SUNDRY NOTICE

Conditions of Approval – January 4, 2012

Grand Valley Pit # 3; Facility ID: 426956

Subject: Engineering Consultation- Existing Pits
Grand Valley Pit #1, #2 and #3
Garfield County, Colorado
Terracon Job No. AD125007

POND #3 (AS-BUILT DRAWING)
LOCATED IN THE SW 1/4 NW 1/4 OF
SECTION 1, T7S, R96W, 6th P.M.

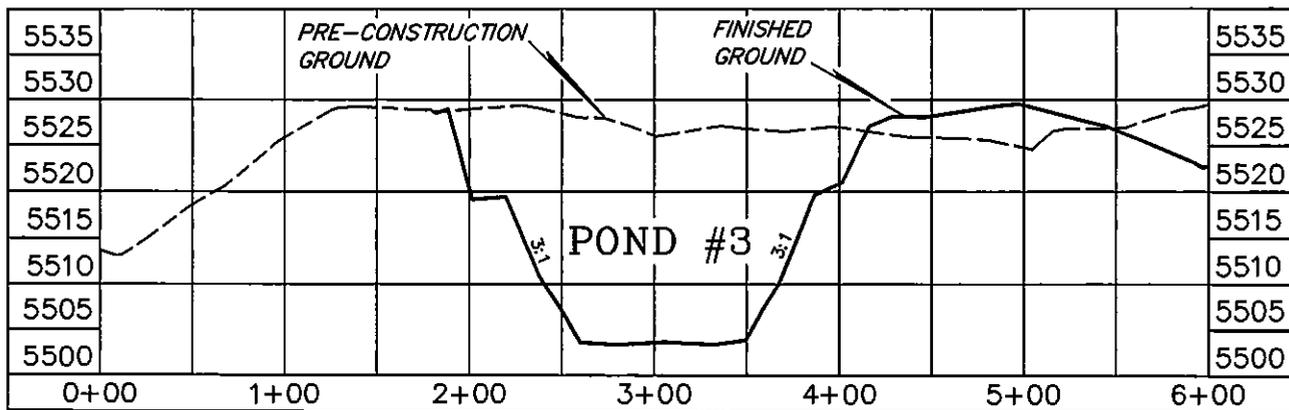
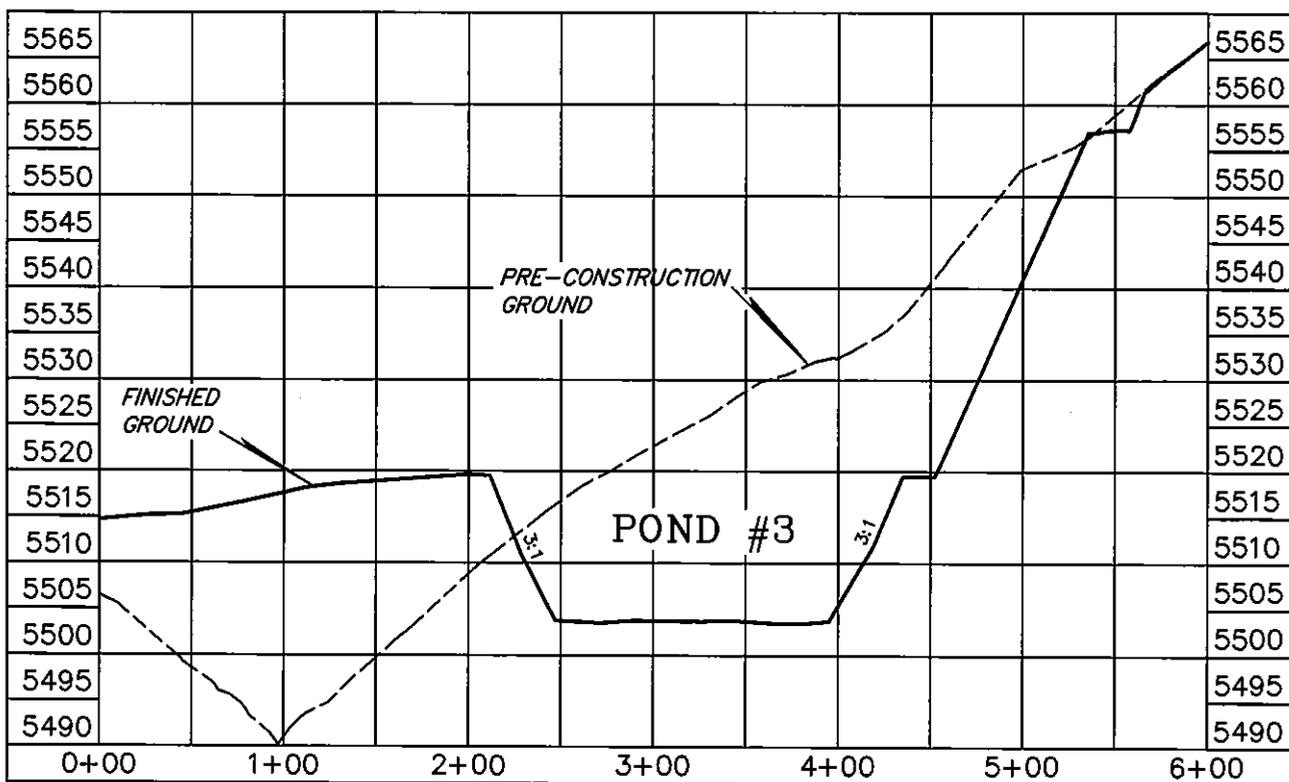
Pit is constructed in fill. Provide a Professional Engineer (P.E.) stamped review of the as-built construction of the pit and integrity of the pit.

Provide the as-built construction details.

Site embankment fills such as in the southwest end of the pits and the dividing areas between pits were not tested. Construction documents (reference Uintah Engineering and Land Surveying, AS-BUILT drawings dated October 28, 2010 for each pit, attached) show existing embankment fill depths varying up to 5 to 10 feet at each of the pits. In our opinion, the amount of time since construction of 2 ½ years with no apparent damages and the level of 24 hour operational monitoring at this site indicate it is very unlikely that any one time event could damage the existing fill to cause a release. However, we do not recommend construction on the embankments unless foundation engineering considers the existence of man made fill. We also believe that a reoccurring yearly reobservation is warranted. We recommend the observations be performed by a Colorado registered P.E. to check for evidence of ongoing fill consolidation or liner tension, considering the lack of construction documentation of fills at the subject site.

The information and limitations contained in this report serves as our review of the as-built construction. Considering existing fill, we believe a reoccurring yearly reobservation made by a Colorado licensed P.E., as described above to check for evidence of fill consolidation, is warranted. The next item,

GRAND VALLEY WATER TREATMENT FACILITY HYDRO-TEST EXHIBIT POND 3

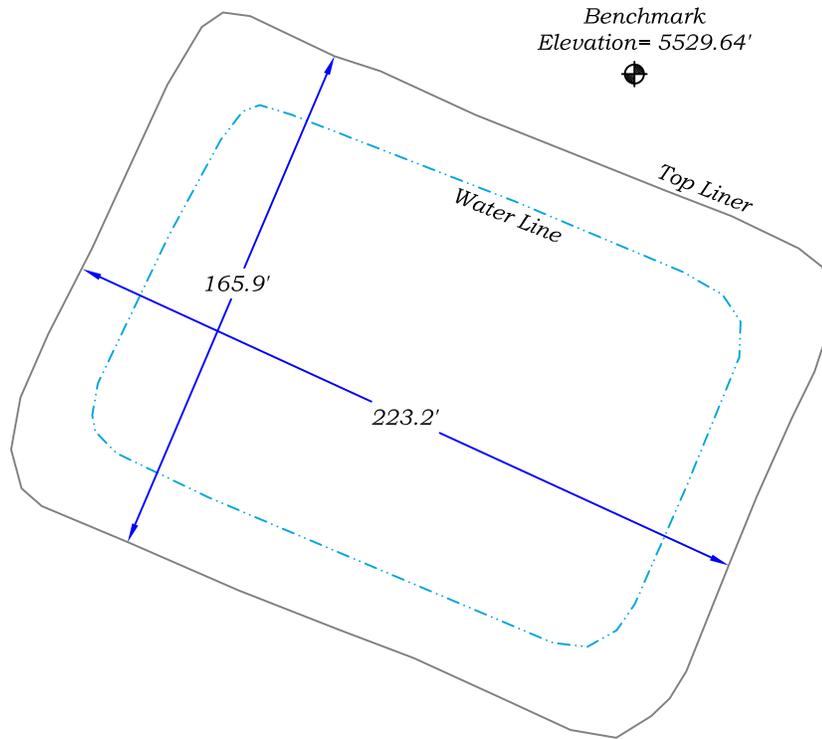
Conduct a 72-hour (minimum) hydrostatic integrity test of the liner system and submit a P.E. review and evaluation of the results of the test.

Calculated Fluid Level Change in Inches:	(+ indicates fluid level increased)	
	(Precipitation - Pan Evaporation + Inflows - Outflows)	0.09 inches
	(Precipitation - 72% Pan Evaporation + Inflows - Outflows)	0.09 inches

Measure Change in Inches:	(+ indicates fluid level increased)	0.00 inches
---------------------------	-------------------------------------	-------------

Liner and Pit Condition: Liner was installed in 2009.
 Visible portion of liner, approximately the top 30 ft., had no apparent tears, delamination or seam failures.
